NOTICE OF ADDENDUM ADDENDUM 1

CONTRACT NO. 9694

WARNER PARK PICKLEBALL COURTS AND WORTHINGTON PARK FUTSAL COURT

SHEET NUMBER:
L203

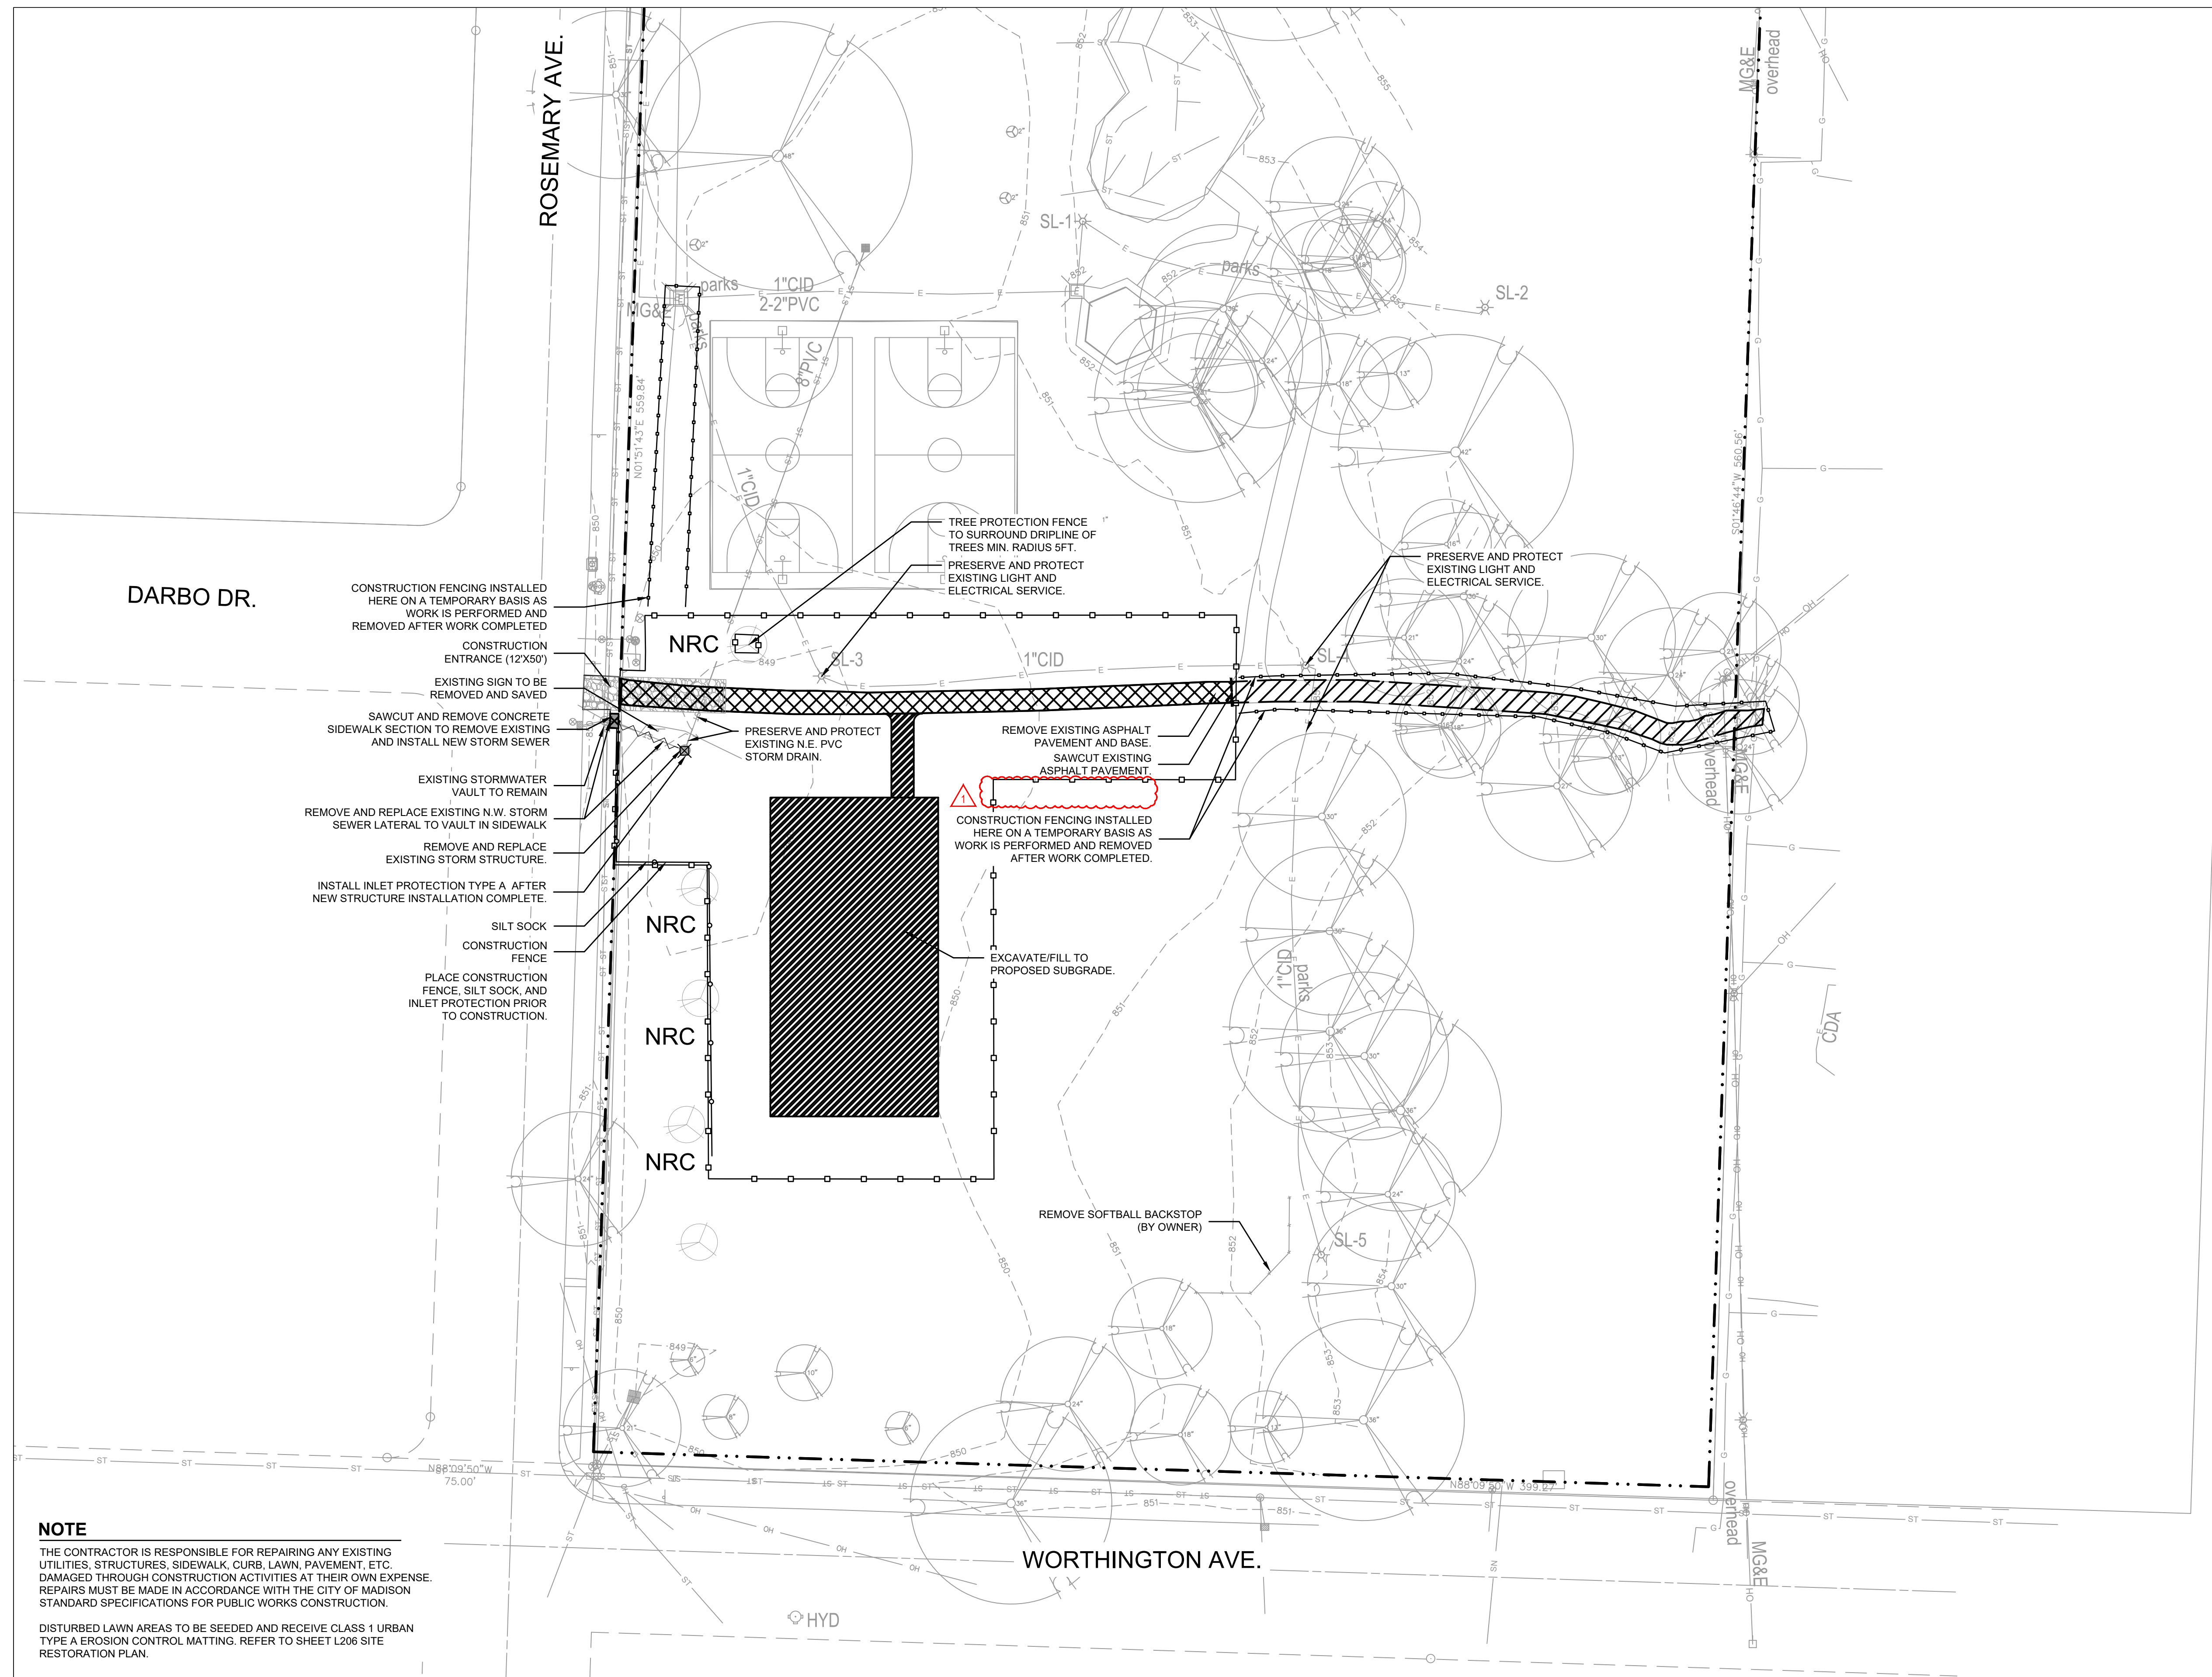
ITEM 1 OMIT callout on L203

Callout no longer relevant to project, see updated sheet L203.
